## AGENDA

- a. Discussion and action on a Site Design Review Permit submitted by Matt Schuenke, Village Administrator, for Phase 2 improvements to the Community Park located at 3234 County Highway AB.
- b. Discussion and action to make a recommendation to the Village Board regarding Resolution 2025-17, a resolution authorizing the Village Administrator to execute a pre-development agreement with Elvehjem Acres LLC and Bliffert Southwest Holdings LLC.
- c. Discussion regarding land division and zoning public notices.

**VILLAGE OF  
McFarland  
SUMMARY SHEET**

We have received the proposed plans for Phase 2 improvements to Community Park, a Village-owned 26-acre site immediately east of CTH B and south of Siggelkow Road. Our comments are shown below, organized by the appropriate document and/or drawing sheet number.

Sheet Title: **SITE LAYOUT PLAN OVERVIEW**

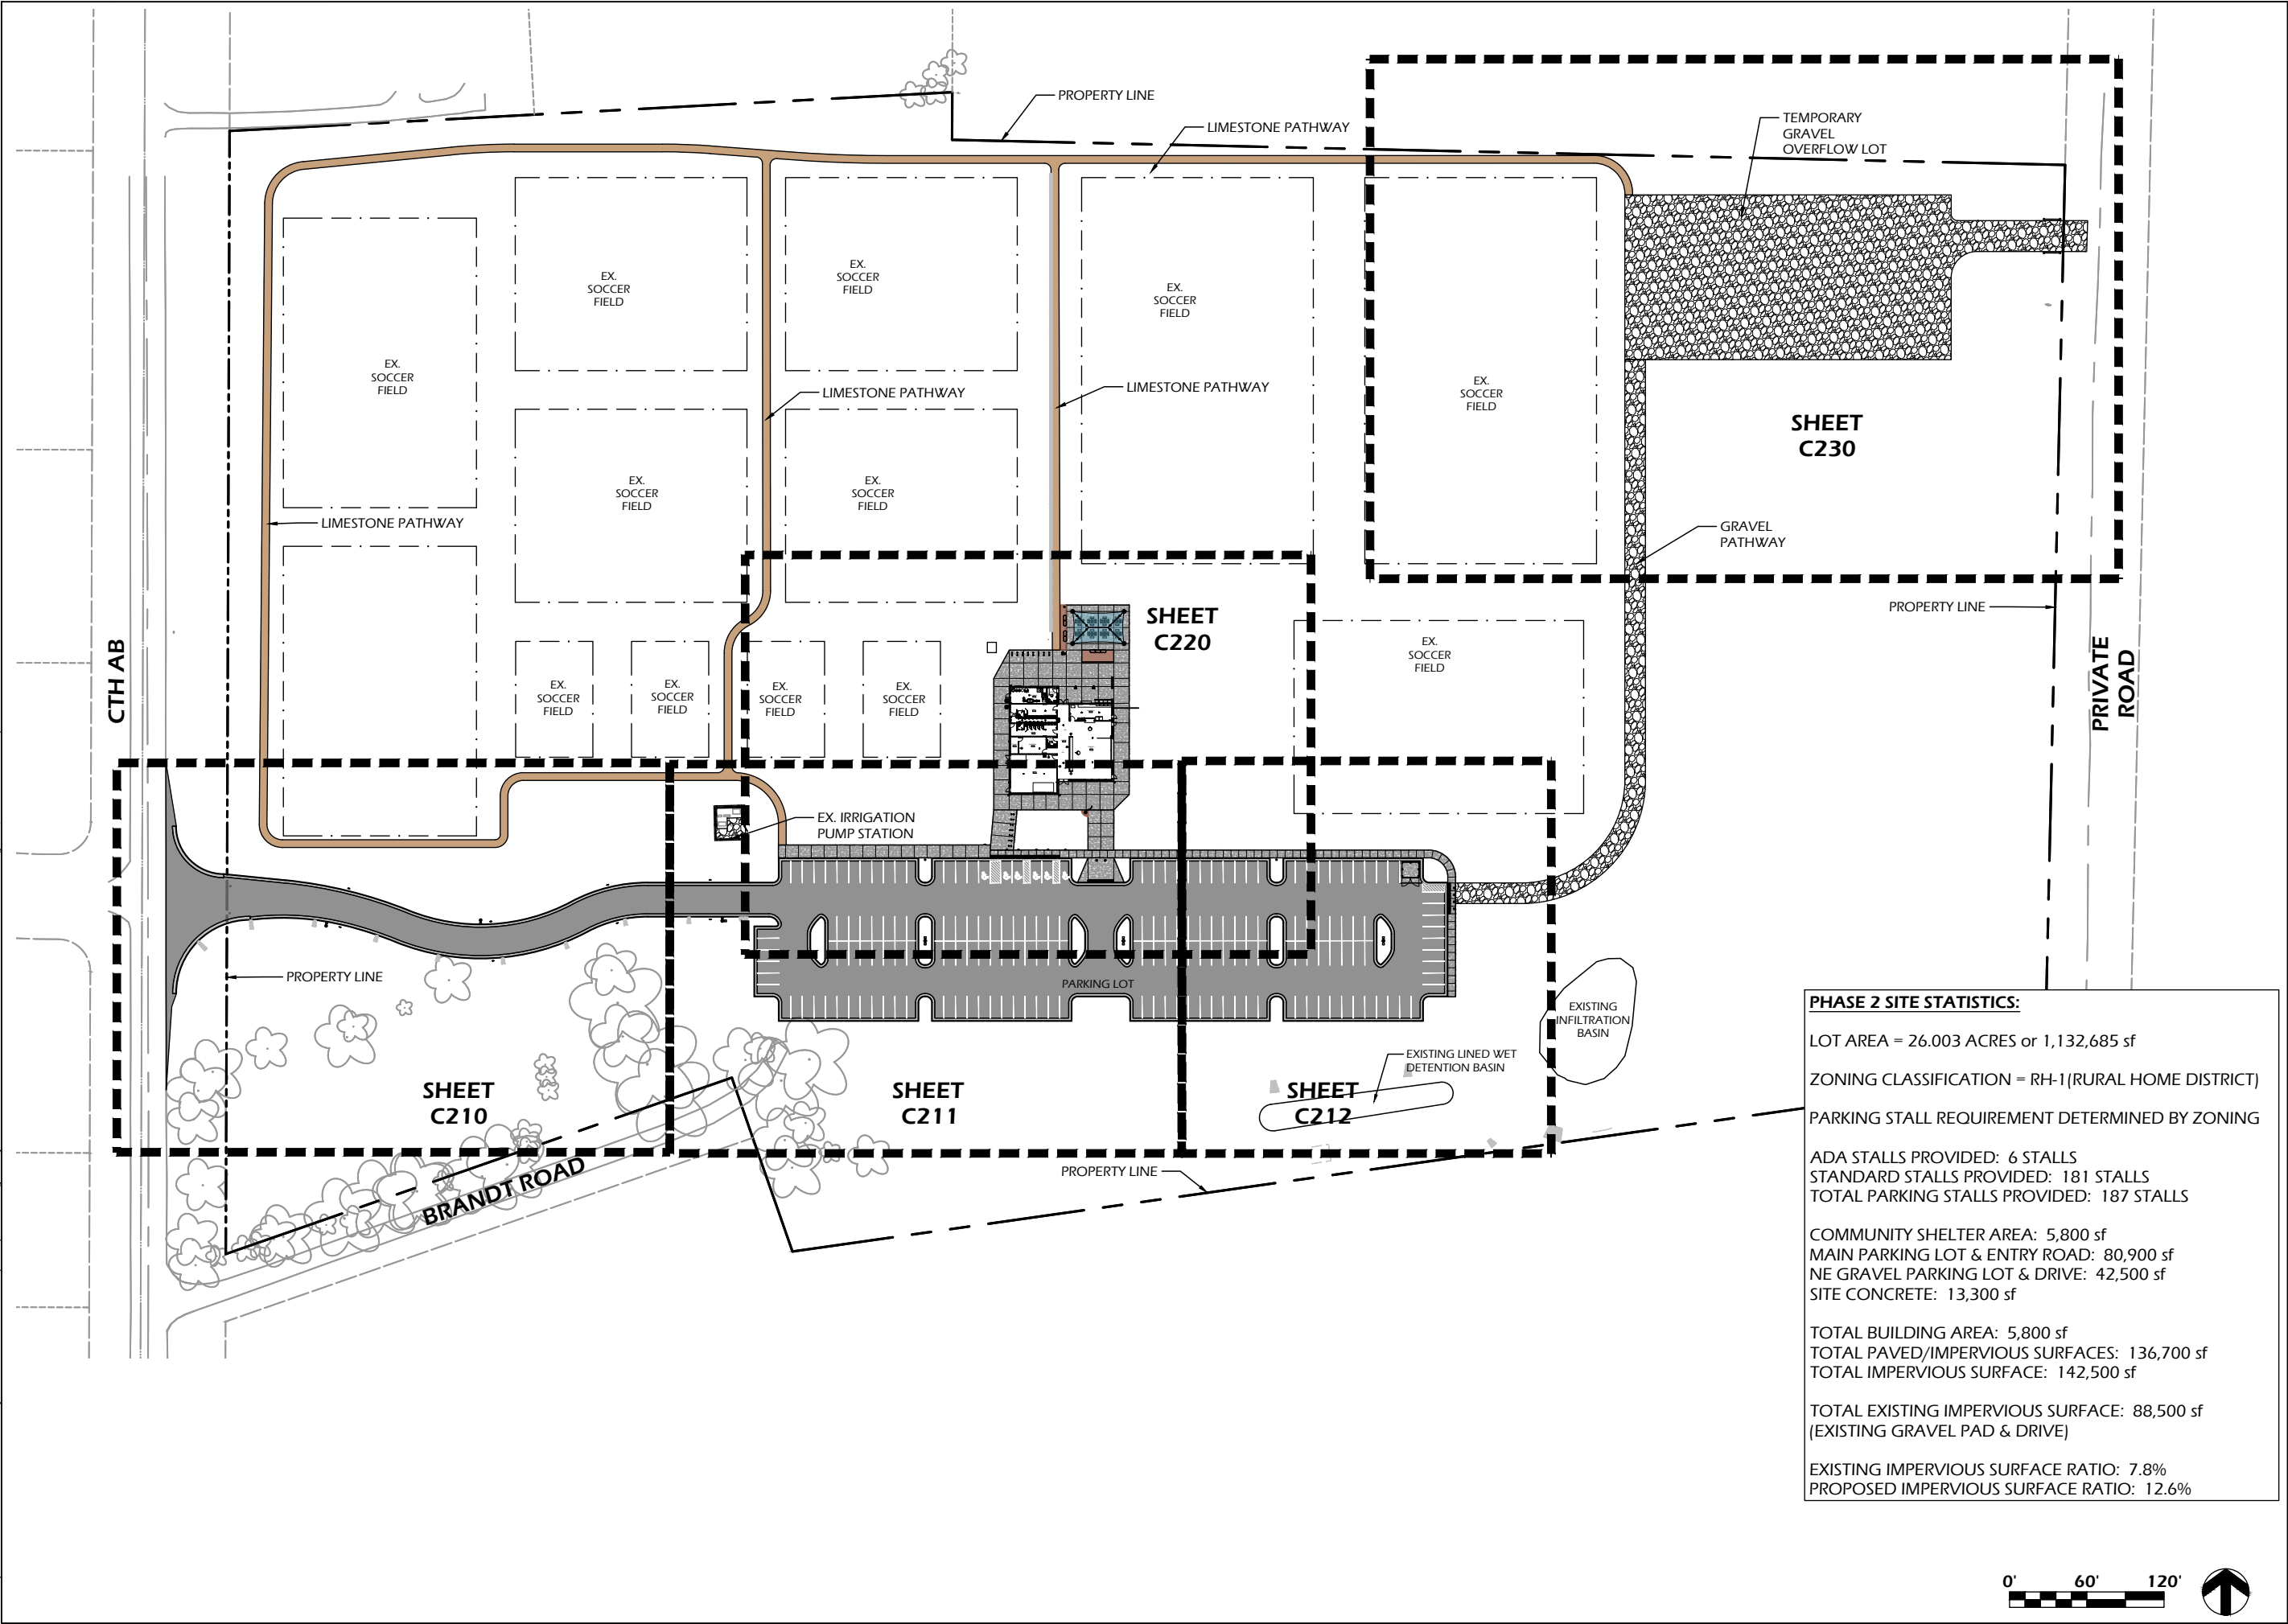
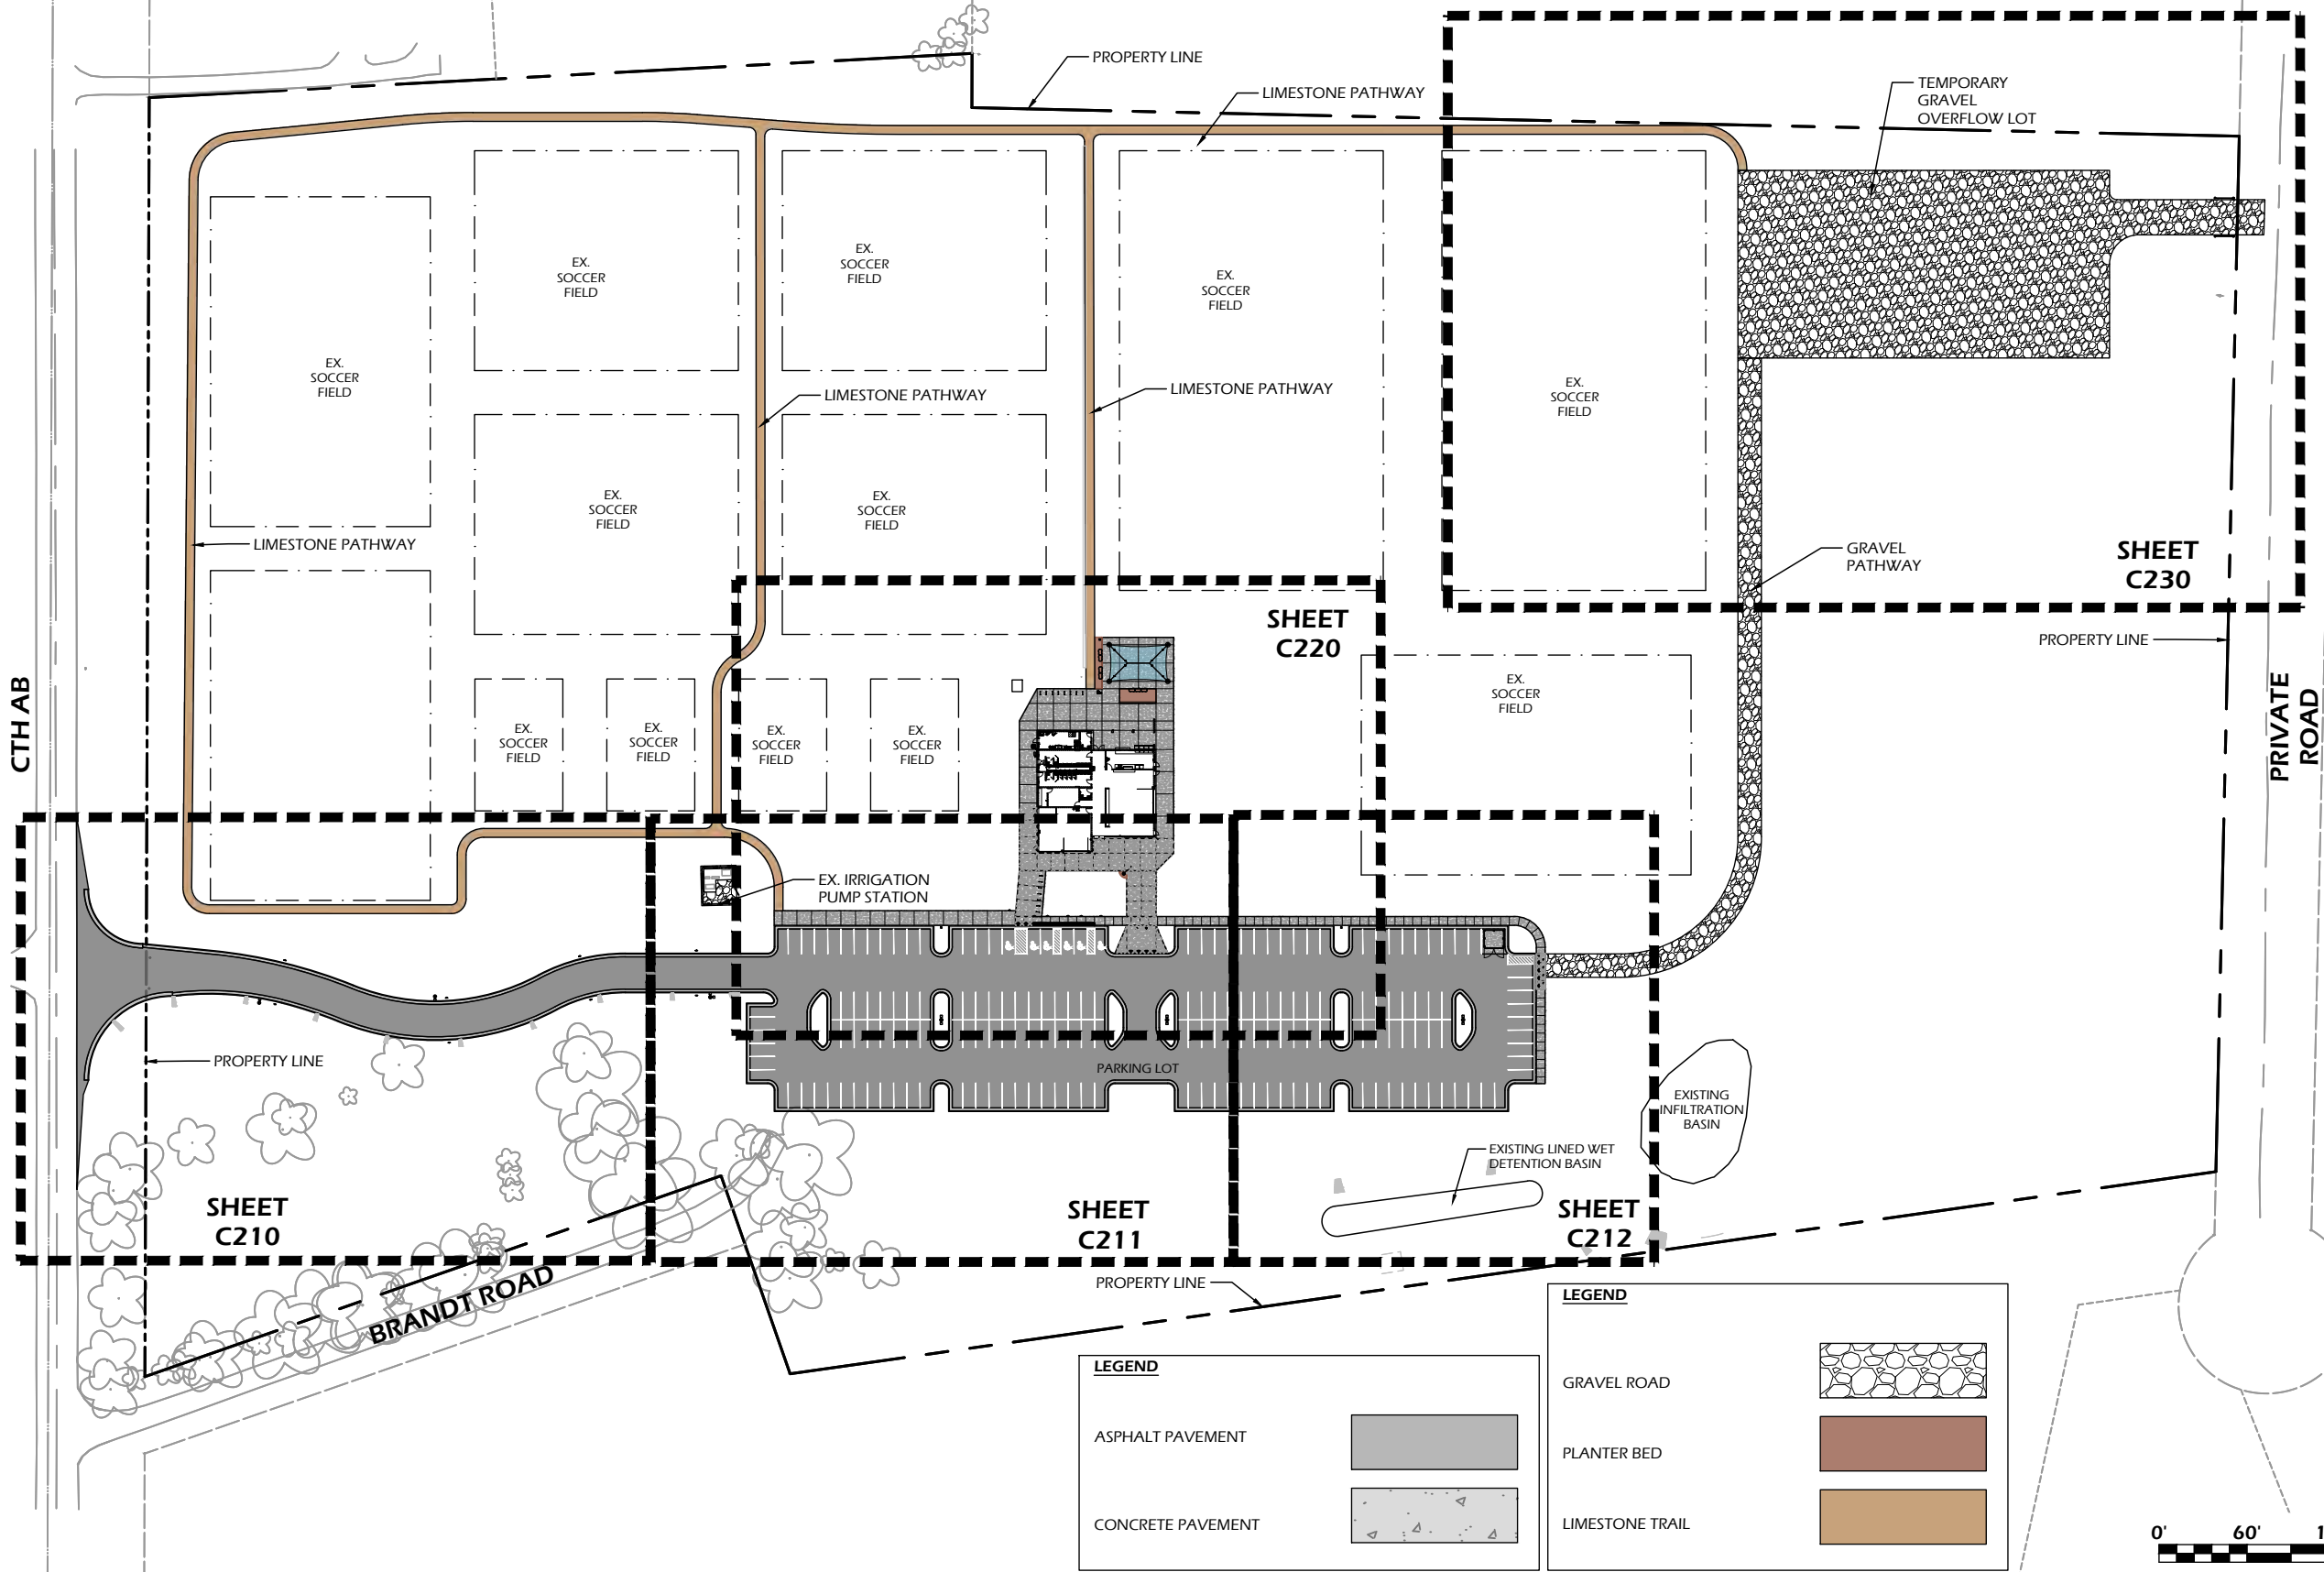
- A network of limestone trails is proposed. We recommend that the radii at 90-degree turns be softened to make future maintenance easier, particularly in the reverse curve sections. Something similar to the radius used near the existing irrigation equipment would be sufficient.
- A portion of the trail near to the shade structure should be moved immediately next to the concrete surface to eliminate an area that may be hard to mow/grow grass.      *A planted landscaping barrier is proposed in this area.*

### **Site Plans**      *Radii on trails have been softened where feasible. Some tighter radii are needed to avoid encroaching into soccer field zones.* Sheet C2
